Metro Central Joint Development Assessment Panel Agenda

Meeting Date and Time: 11 September 2017; 2pm
Meeting Number: MCJDAP/255
Meeting Venue: City of South Perth
Cnr Sandgate and South Terrace
South Perth

- 8.1** Property Location: Lot 413 (No. 47) Clydesdale Street, Como
Application Details: 21 Multiple Dwellings within a 5 Level Development
Applicant: Aidan Gorjy (47 Clydesdale Pty Ltd)
Owner: Ruben and Lois Lane
Responsible Authority: City of South Perth
DAP File No: DAP/17/01235
- 8.2** Property Location: Lot: 1961 Plan: 67423, 28 Colombo Street
VICTORIA PARK
Application Details: ADDITIONS & ALTERATIONS TO EDUCATIONAL ESTABLISHMENT
Applicant: T & Z Architects
Owner: Regent College Inc
Responsible Authority: Town of Victoria Park
DAP File No: DAP/17/01219

9.1	Property Location:	Lot 25 (No. 300) Collier Road, Bassendean
	Application Details:	Convenience Store
	Applicant:	Planning Solutions
	Owner:	HICON (WA) PTY LTD
	Responsible Authority:	Town of Bassendean
	DAP File No:	DAP/17/01187

Figure 3 - Swept Paths for fuel tanker (with previous DoP recommendations in red)

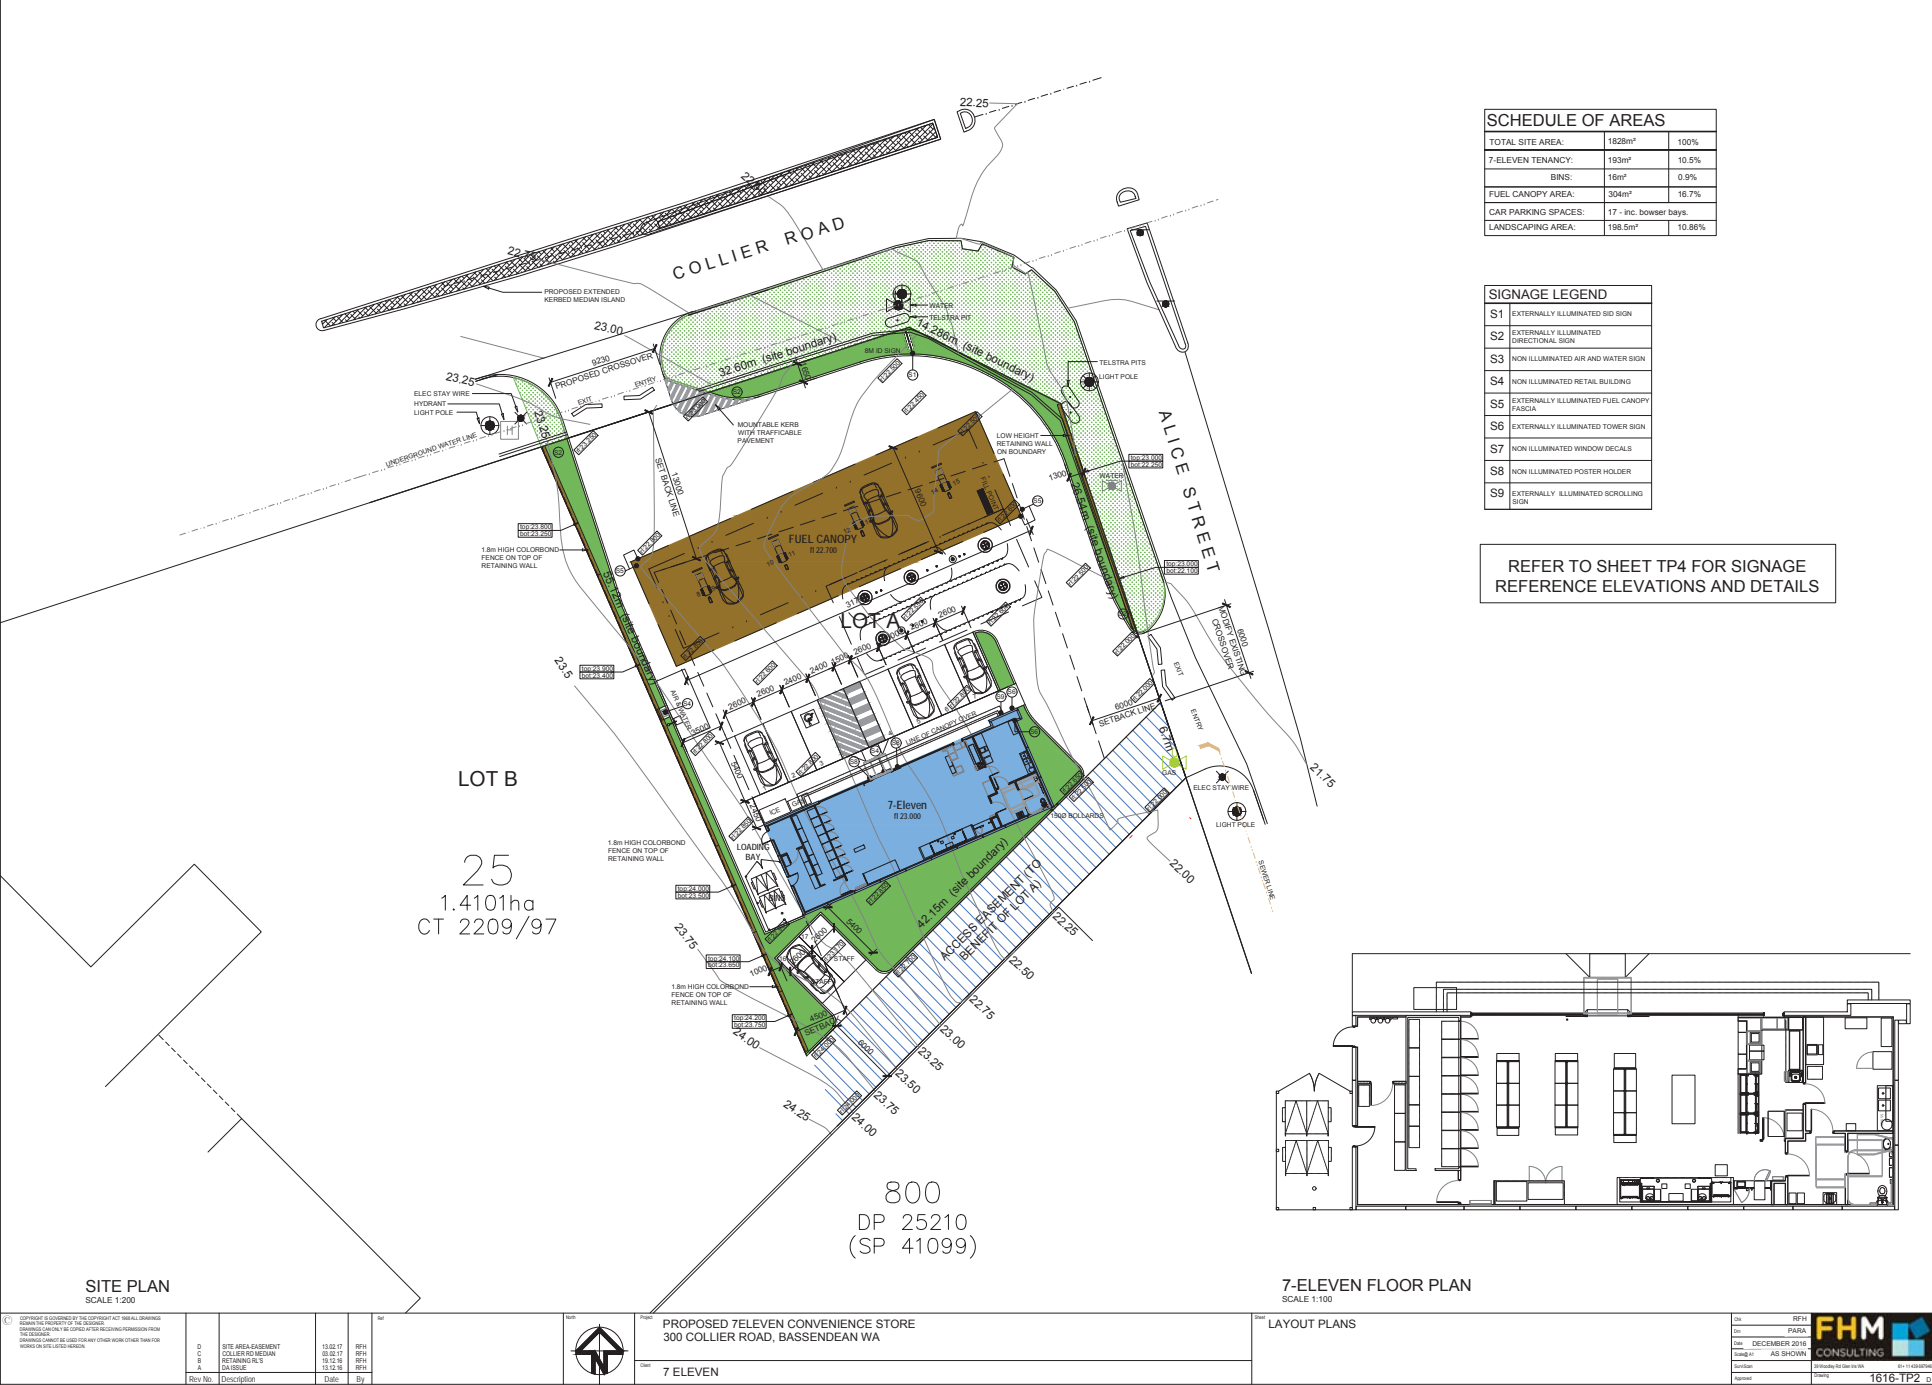
It is understood that the swept paths shown in **Figure 17** are based on the movements of a 19m long fuel tanker. The Department recommends consideration be given to making minor modifications as follows:

Figure 17 - Recommended changes to kerbs for fuel tanker access

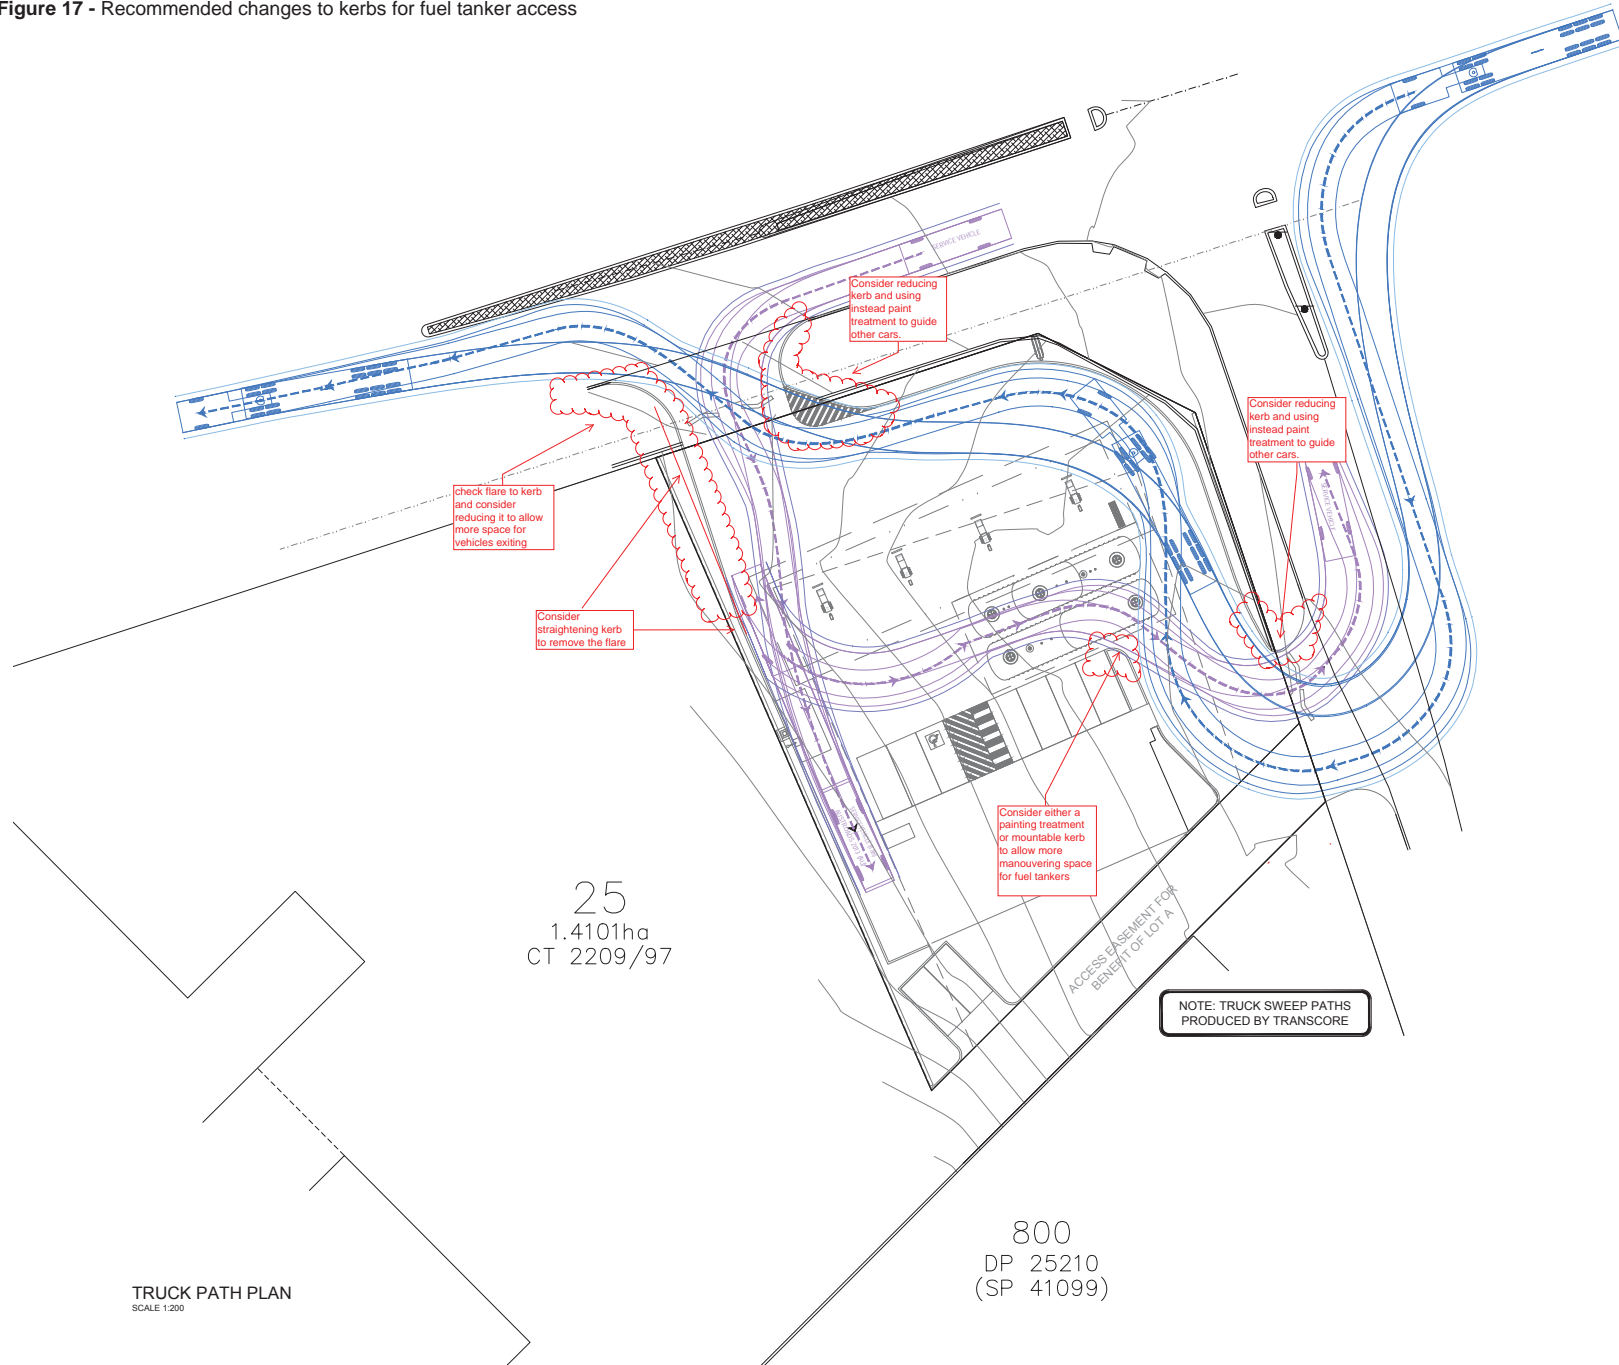
These recommendations are shown in red on the marked up map shown at **Figure 17**.

- b. A reduced height to S1 – High Main Price Board to a maximum height of 6m.
 - c. Straightening of the kerb on the western side of the site to increase the width of the proposed crossover as shown in red on drawing titled Figure 17. The crossover wing radius must be a minimum of 5.0m in accordance with the Towns crossover specifications.
